General Accounting Office

More Assurance Is Needed That Strategic Petroleum Reserve Oil Can Be Withdrawn As Designed

GAO/RCED-85-104
SEPTEMBER 27, 1985

Figure 2.1: SPR Phase II Drawdown Capability

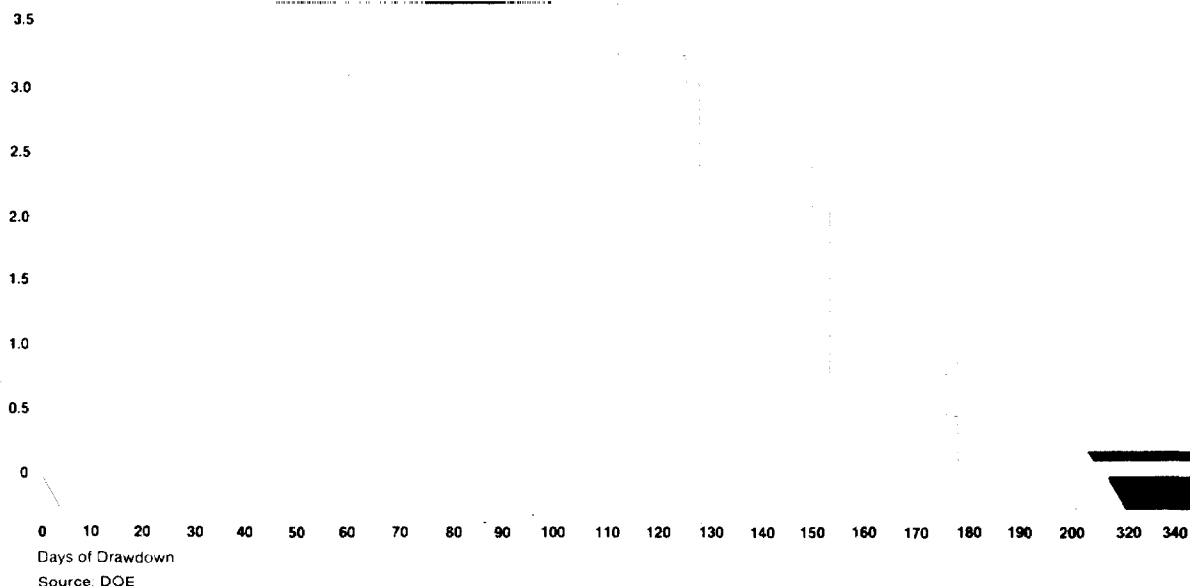
The model used to project the phase II drawdown rates assumes that currently needed modifications to equipment and facilities have been completed. Among these are pump and piping modifications at the storage sites; converting cavern piping to drawdown configuration; and distribution system enhancements at Bryan Mound which, in addition to replacing and upgrading distribution capability, allow simultaneous withdrawal of two types of crude oil.

The model also assumes that all equipment operates at designed performance levels. DOE is planning to make changes to meet these conditions. We believe, however, that the assumption reflects an ideal situation, which may be difficult to achieve and/or sustain under actual operating conditions and may produce a higher level of confidence than is warranted. Chapter 3 discusses a number of technical problems facing DOE in assuring that the drawdown systems operate as designed. For example, DOE has had continuing problems with the submersible pumps at the Weeks Island site that have affected their capability to operate at design levels even though they have had only a few hundred hours of operating time. In addition, we noted that silt buildup around the raw water intake structure at Bryan Mound has been a continuing problem affecting pump performance. While DOE has taken steps to resolve this problem, it is possible that silt buildup may recur when the larger volumes of water needed for drawdown flow through the intake system causing an unanticipated strain on the pumps. Further, we pointed out that DOE has not
